L4C Interface

Title L4C Interface Board			
Size: C	DCC Number: D1002739		Ligo Project California Institute of Technology Massachusetts Institute of Technology Cannot open file C:\Ben\miscellan\ligologo_t.jpg
Drawn by: Ben Abbott	Date: 2/3/2020	Revision: v4	
File: C:\Dean\A+\D1002432 BSC ISI Interface Chassis\D1002739 L4C Interface Board\A+ L4C Interface Board SchDoc

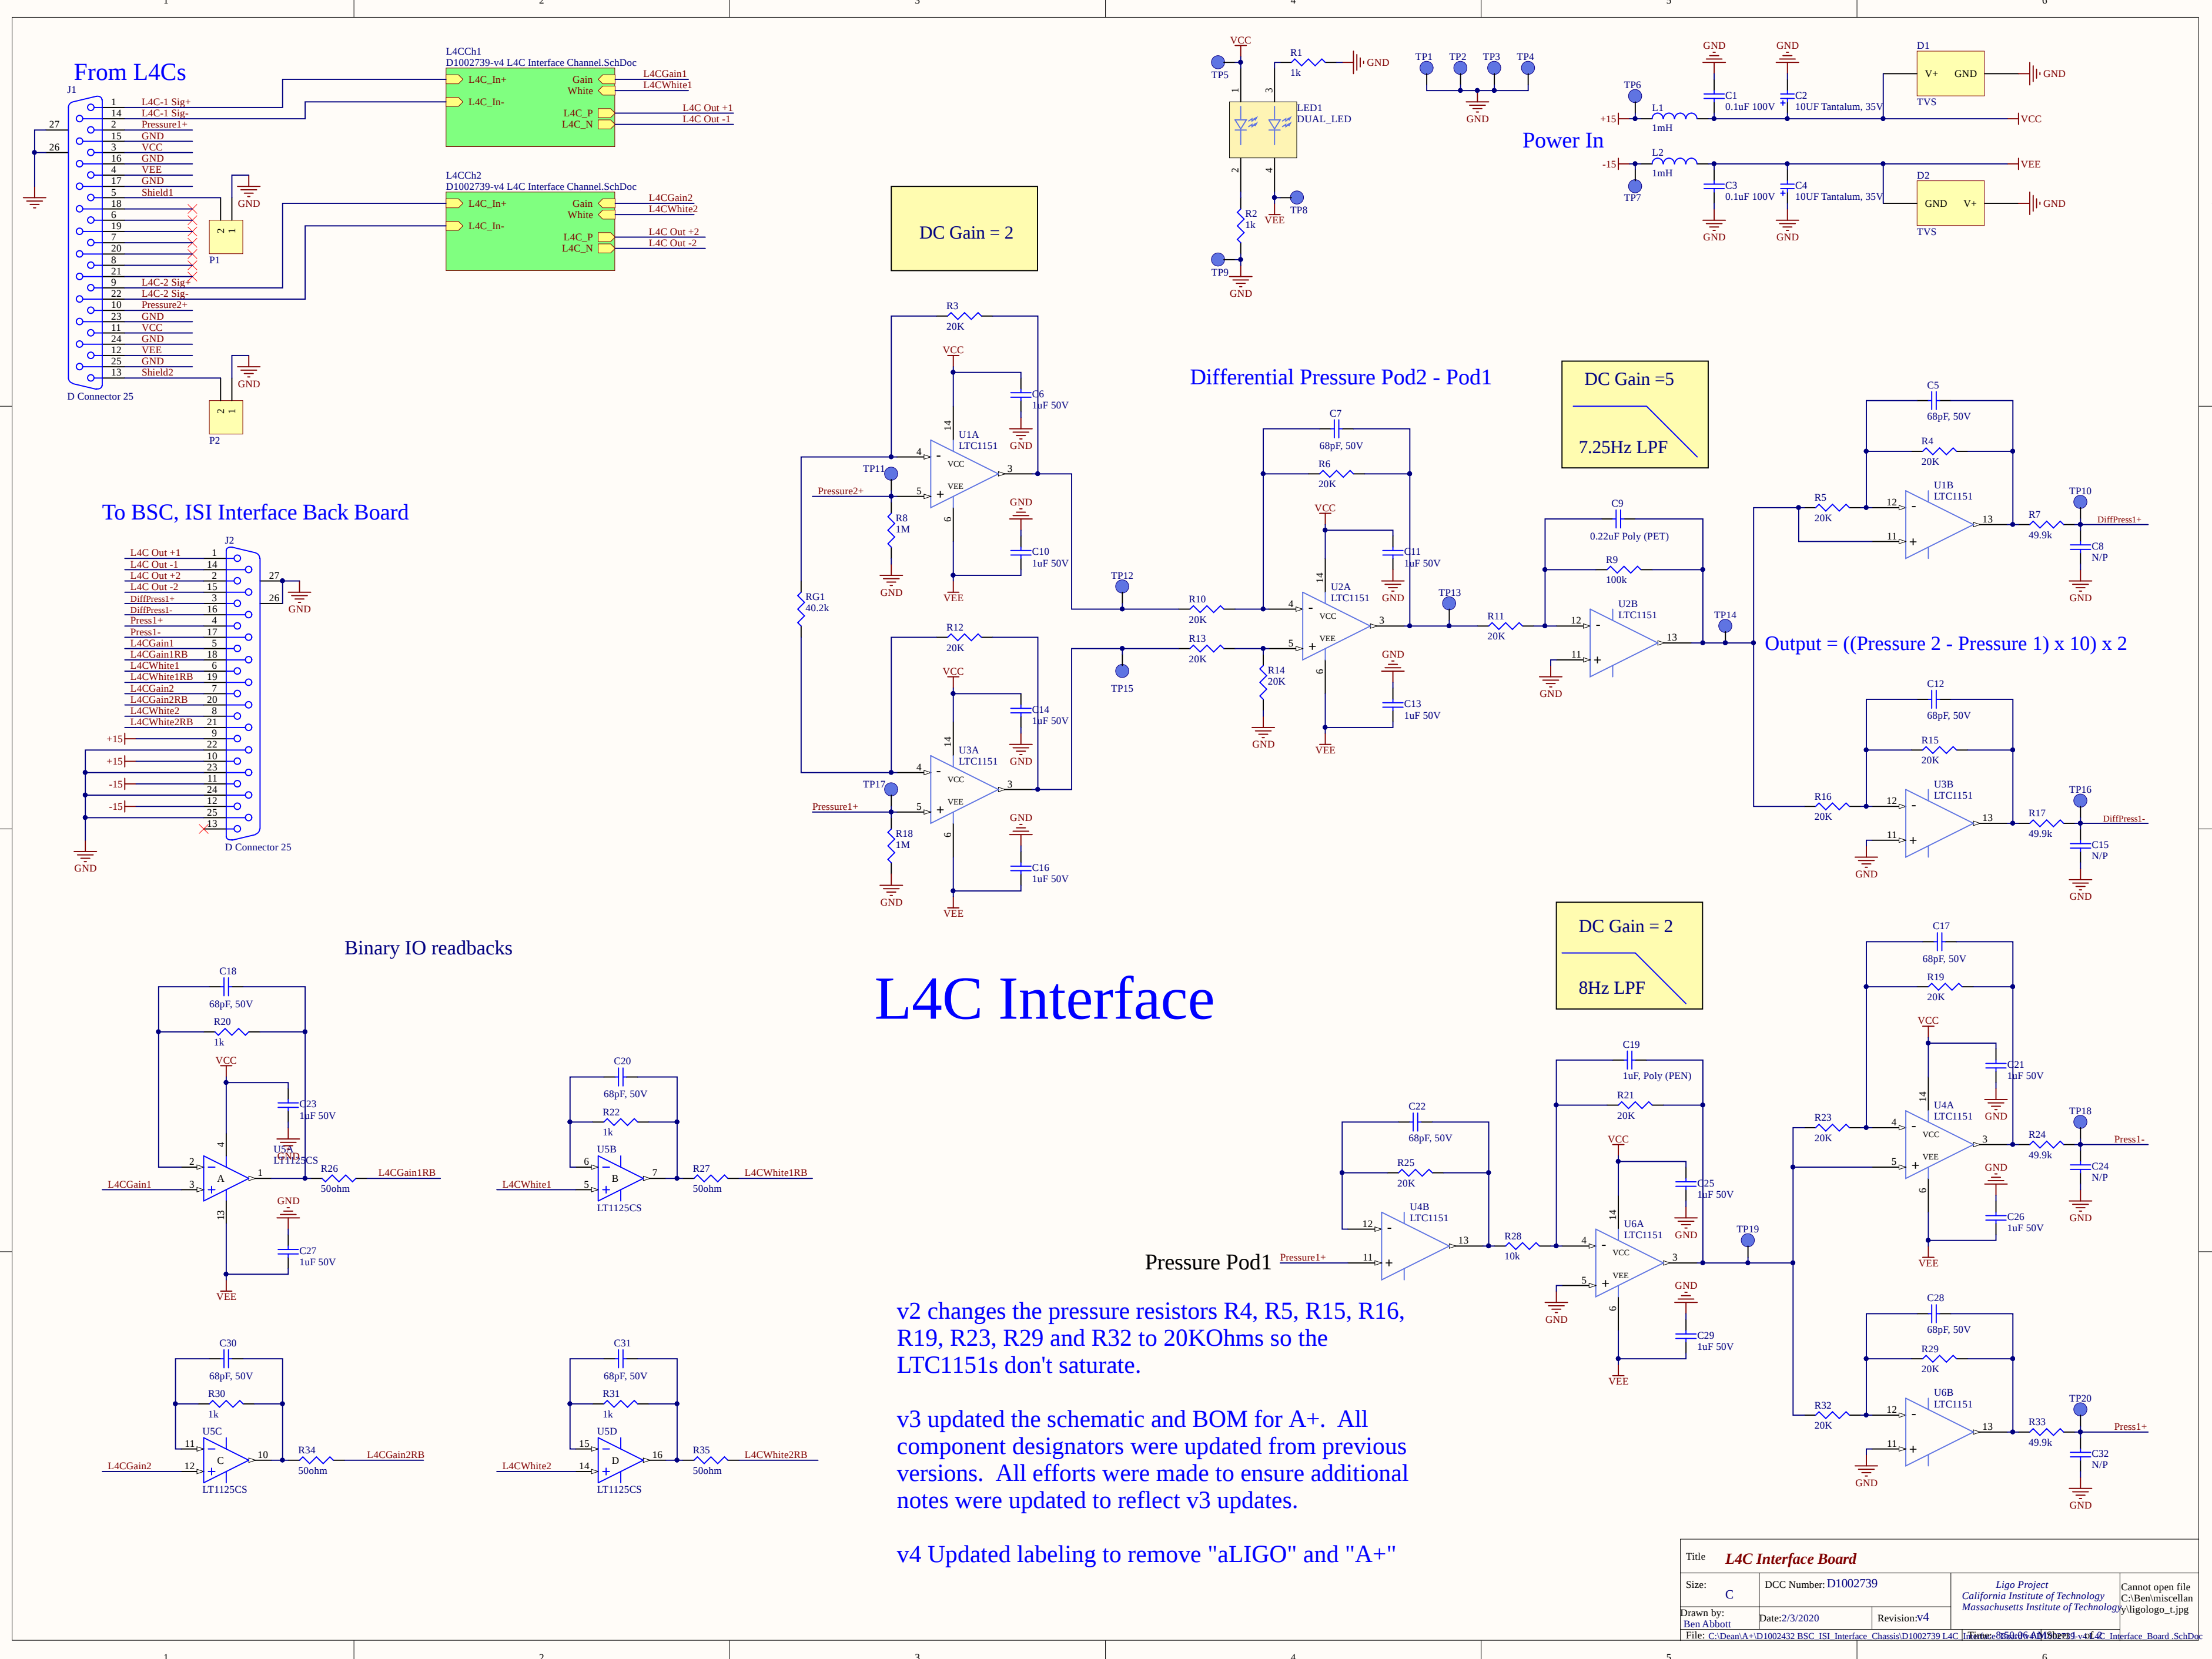
v2 changes the pressure resistors R4, R5, R15, R16, R19, R23, R29 and R32 to 20KOhms so the LTC1151s don't saturate.

v3 updated the schematic and BOM for A+. All component designators were updated from previous versions. All efforts were made to ensure additional notes were updated to reflect v3 updates.

v4 Updated labeling to remove "aLIGO" and "A+"
